South Texas Project
Units 1 and 2
Docket Nos. STN 50-498, STN 50-499
Response to Requests for Additional Information for the
South Texas Project License Renewal Application
Aging Management Program, Set 16 (TAC Nos. ME4936 and ME4937)

Selective Leaching of Aluminum Bronze Program (111)

RAI B2.1.37-3

Figure A-1

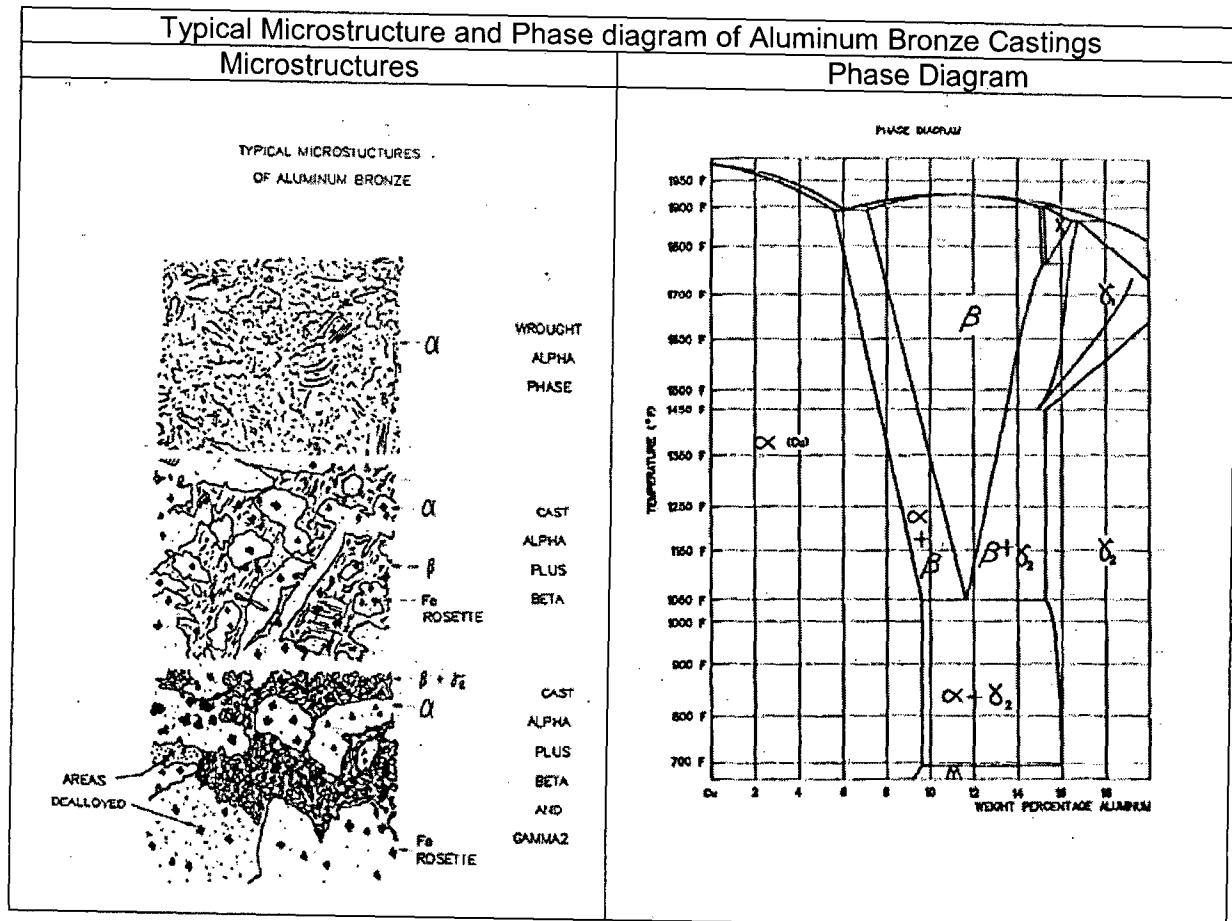
- a. State the phase composition of the material of the susceptible components (e.g., γ_2 , β , a). State which phase(s) of the material are significantly present, which phase is the continuous phase, and which phase(s) are leached. Given the composition of the dealloyed components identified to date, state the basis for why the ultimate tensile strength used in the structural analysis of the degraded components is a conservative value. Provide metallurgical analyses including micrographs and chemical analyses sufficient to demonstrate an understanding of the phase distributions, including whether

Figure A-1 provides a typical microstructure and phase diagram of aluminum bronze castings.

Figure G-1

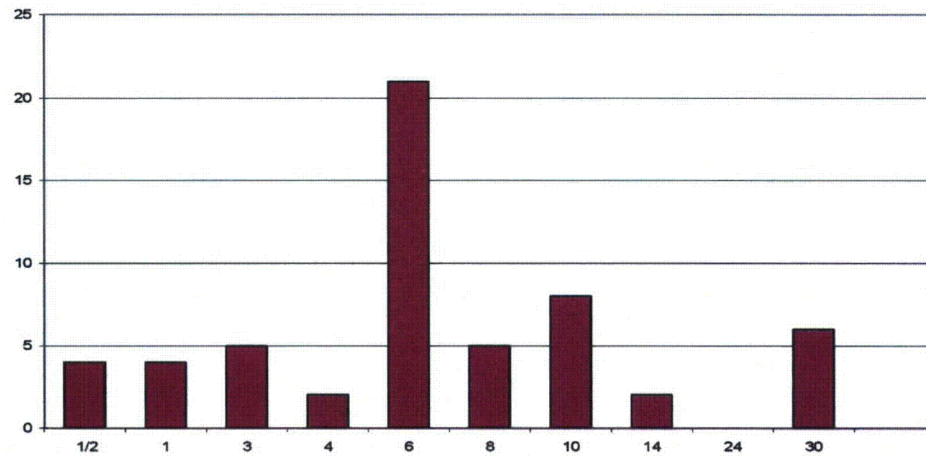
- g. Revise LRA Sections A1.37 and B2.1.37, and Commitment No. 39 to reflect:
- A sample size that is sufficiently statistically-based to confirm that the extent of further dealloying or crack propagation is known.

The following figures show some of the data that STP has collected over the years regarding the ECW system failures. The important points regarding these plots are as follows:

- The overall failure rate has declined since discovery of dealloying in 1987.
- The highest numbers of failures occurred early in the life of the plant, representing the infant mortality part of a bathtub curve.
- The failure rate suggests that the most susceptible components have already failed.
- The declining trend in the number of failures is due in part to a decrease in the at-risk population of cast components after they were replaced with wrought aluminum bronze material in 1990.
